L-2012-444

Re: Turkey Point Units 3 and 4
Docket No. 50-250 and 50-251
License Renewal Pressurizer Surge Line Welds Inspection Program
Response to Request for Additional Information

Responses to the NRC Request for Additional Information

Figure 1, Comparison of Fatigue Crack Growth with R-ratio = 0.

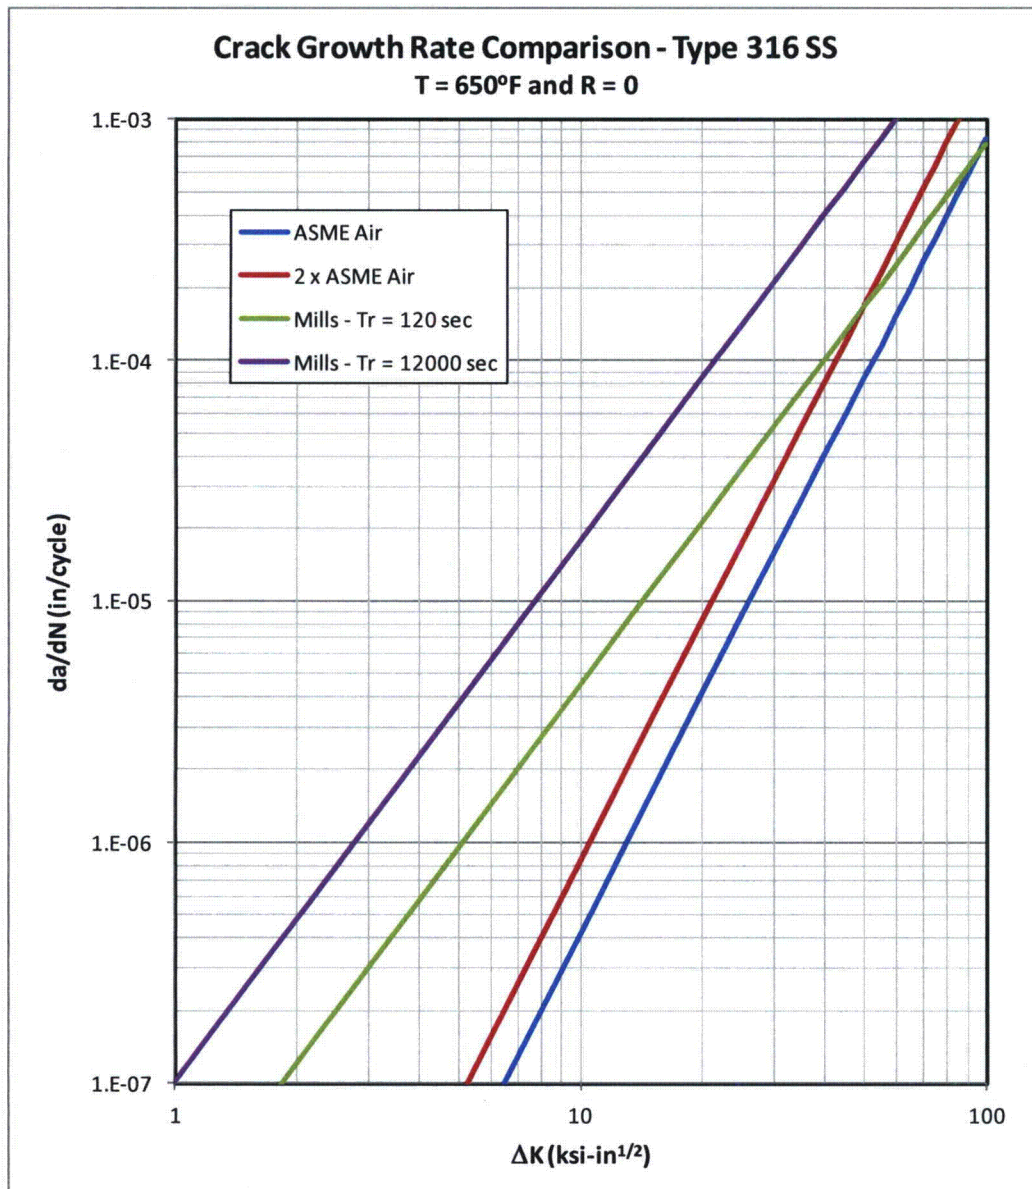
Provide a technical basis to justify that use of the referenced formulation is conservative with respect to the calculation of the fatigue crack growth rate in a pressurized water reactor environment. Describe how this formulation takes into account the parameters discussed in Section XI, Subarticle C-8410, including temperature, ratio of the minimum stress intensity factor to the maximum stress intensity factor associated with the transient stress range, and the environment.

For a low rise time of 120 seconds, it can be seen from Figure 1 that, for an R-ratio equal to zero, the formulation used in the evaluation produces more conservative crack growth results than using the ASME Code crack growth curve with a factor of 2 for ΔK values less than 50 ksi-in^{1/2}. Similarly, Figure 2 shows that, for a low rise time of 120 seconds and an R-ratio equal to 1, the formulation used in the evaluation produces more conservative crack growth results than using the ASME Code crack growth curve with a factor of 2 for ΔK values less than 30 ksi-in^{1/2}.

Both Figures 1 and 2 show that, with a rise time of 12000 seconds, the formulation used in the evaluation is conservative compared to 2 times the ASME Code crack growth rate in air for ΔK values less than 70 ksi-in^{1/2}. In the evaluation, a conservatively large rise time of 15732 seconds representing a heatup transient was used for all the cyclic loads and the maximum calculated ΔK was 39.3 ksi-in^{1/2}. Therefore, the formulation used in the evaluation is conservative for the calculation of the fatigue crack growth of stainless steel components in a pressurized water reactor environment.

Figure 1. Effect of Strain Rate on SCC of Alloy 600 and Types 304 and 316 Austenitic Stainless Steels (SS) (Ref 1)

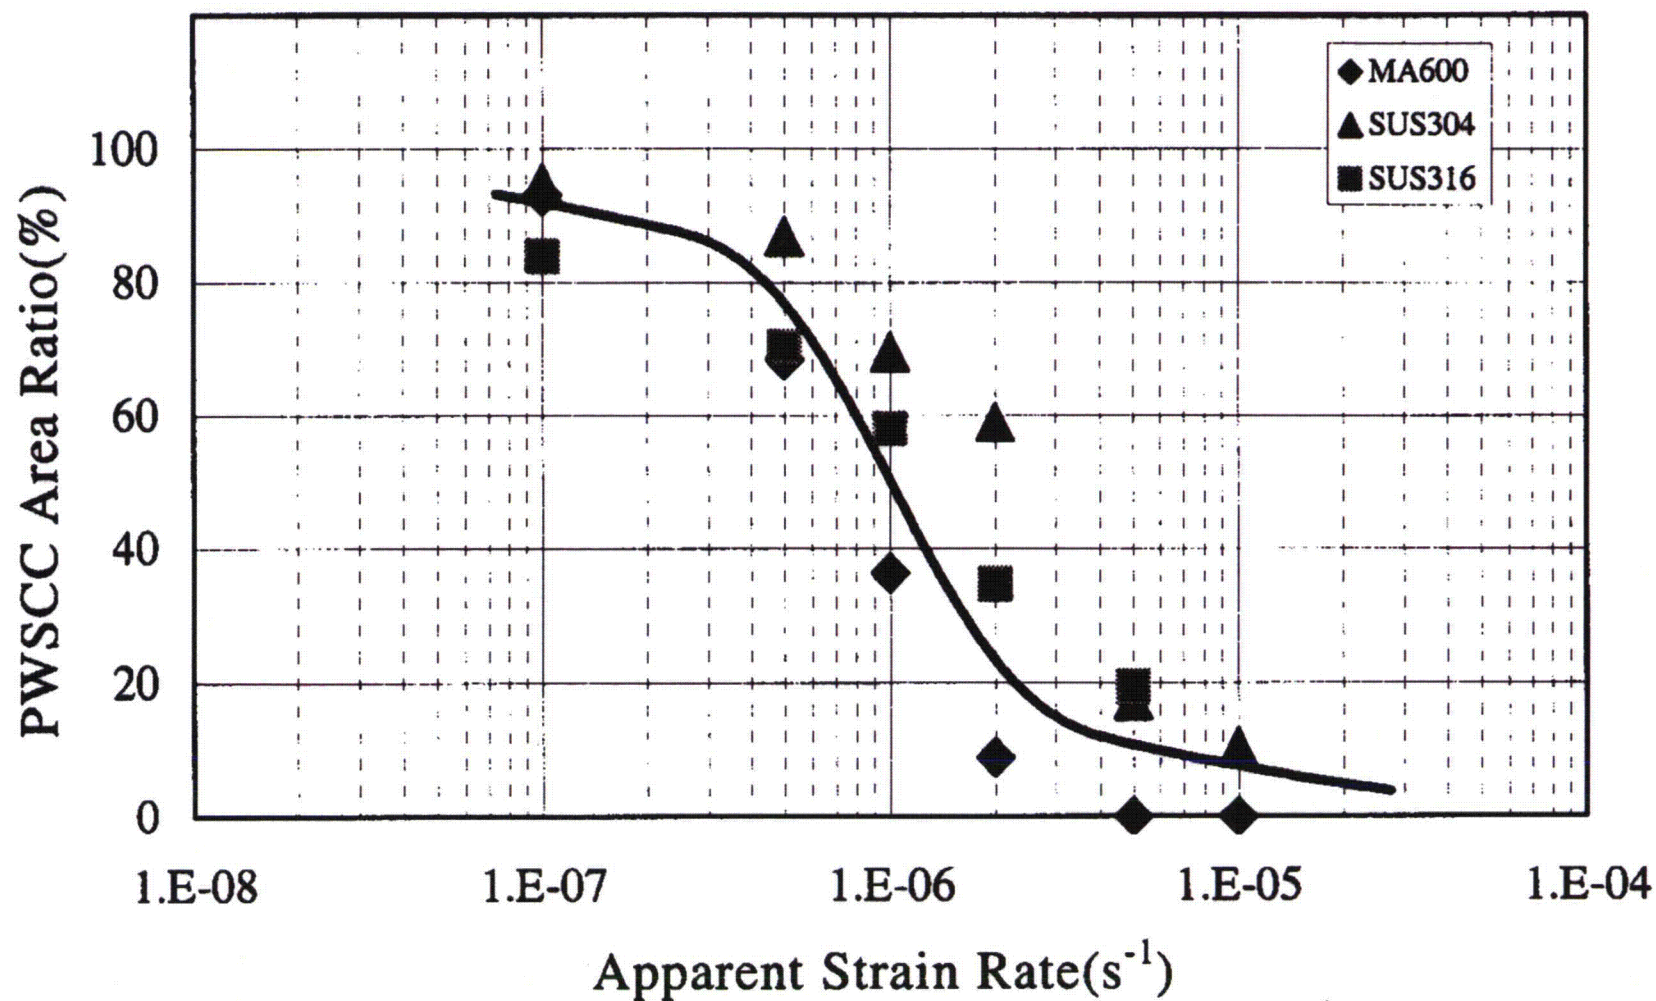
Describe how and justify that the flaw growth evaluation accounted for the effects of stress corrosion cracking. Alternatively, provide the basis for not considering the effects of stress corrosion cracking in the evaluation.

As illustrated in Figure 1, austenitic stainless steels are susceptible to stress corrosion cracking (SCC) in PWR environments in a similar fashion as Alloy 600 (Reference 1). To distinguish the SCC of nickel base alloys in PWR environments, i.e., primary water stress corrosion cracking (PWSCC), a new SCC term, i.e., low potential stress corrosion cracking (LPSCC) is often used to describe the SCC of austenitic stainless steels in PWR environments.
